Subject: Duke Energy Corporation
Catawba Nuclear Station Unit 1 and 2
Docket No.: 50-413, 50-414
Core Operating Limits Report (COLR)

Attached, pursuant to Catawba Technical Specification 5.6.5, is an information copy of the revisions to the Core Operating Limits Report for Catawba Unit 2 Cycle 11 and Catawba Unit 1 Cycle 12. Revision 17 to the Unit 2 COLR is being made to update the limits for the new Catawba 2 Cycle 11 reload core. Along with the power distribution surveillance data (Appendix A) which changes each cycle, this revision also includes the following changes:

Catawba Unit 1 Cycle 12
Core Operating Limits Report
Revision 17

Catawba Unit 2 Cycle 11
Core Operating Limits Report
Revision 17
February 2000

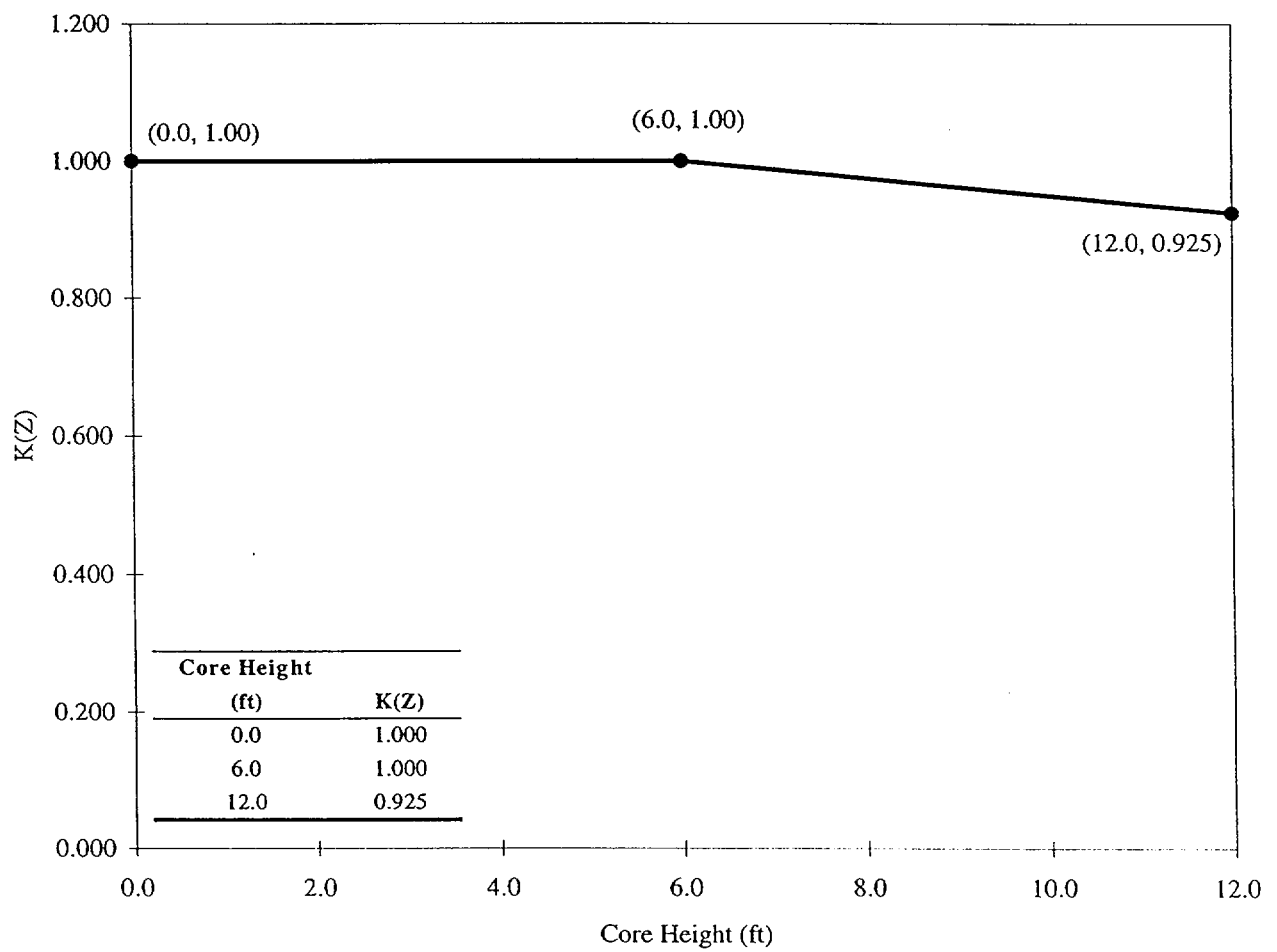
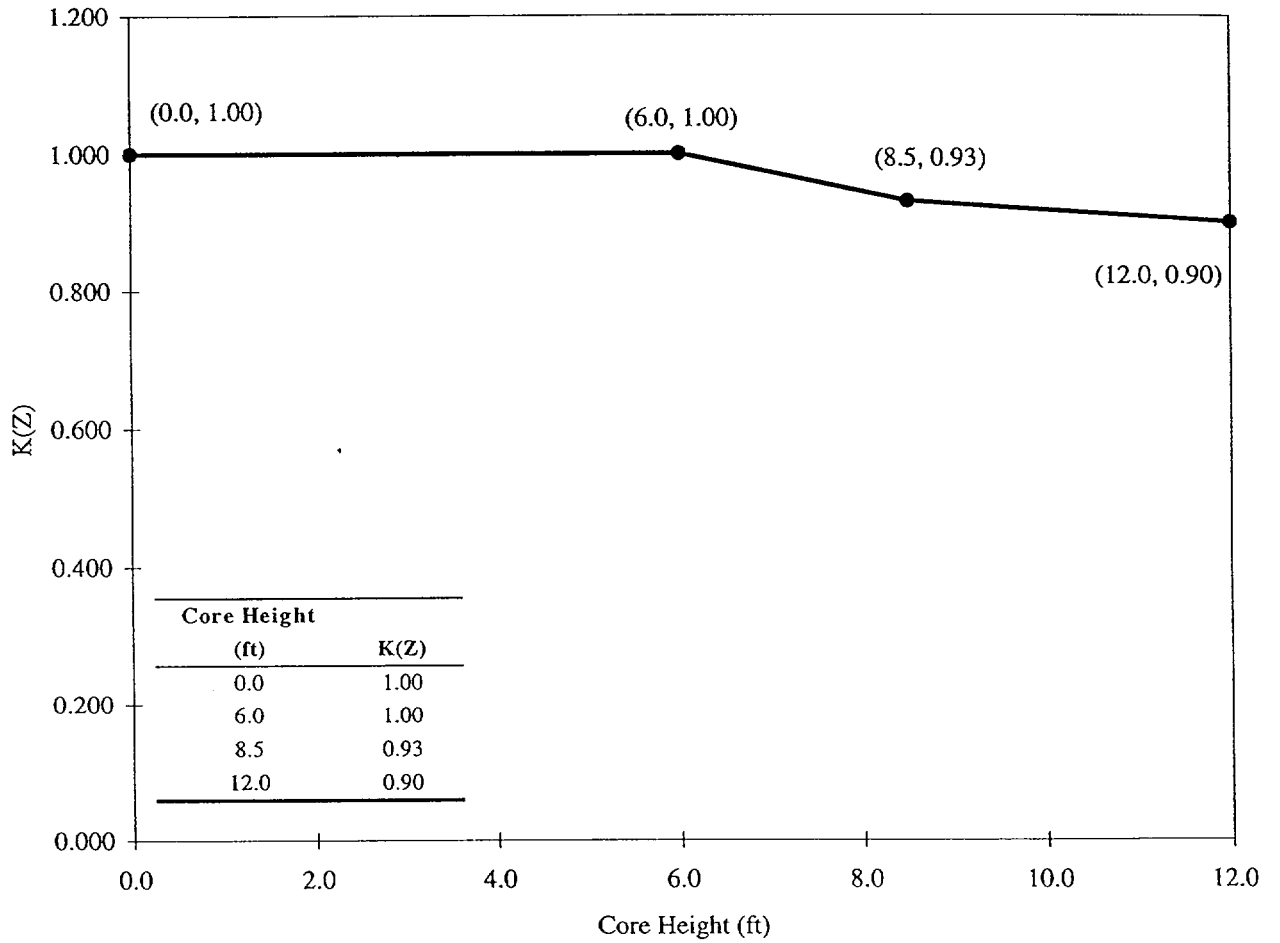
1. The 31-day EFPD Penalty Factor information has been added as Table 1.
2. The K(Z) curves for MkbW and Westinghouse RFA fuel, Figures 3 and 4, have been updated to correspond to the Westinghouse LOCA analyses.
3. The FAH LCO MARP table has been relocated from Appendix A, Table 7 to Table 2. Appendix A now contains only cycle specific power distribution surveillance Monitoring Factors.
4. The Full Power Negative AFD limit shown in Figure 5 has been reduced from -20% to -18%.
5. The column labels for Sections 2.8.1 and 2.8.2 have been changed from "Value" to "Nominal Value".
6. COLR sections 2.25, 2.26 and 2.27 have been rearranged to be sequentially consistent with the Selected Licensee Commitments (SLC). The contents of these sections were not changed.

2.5.3 $K(Z)$ is the normalized $F_Q(X,Y,Z)$ as a function of core height. $K(Z)$ for MkBW fuel is provided in Figure 3, and the $K(Z)$ for Westinghouse RFA fuel is provided in Figure 4.
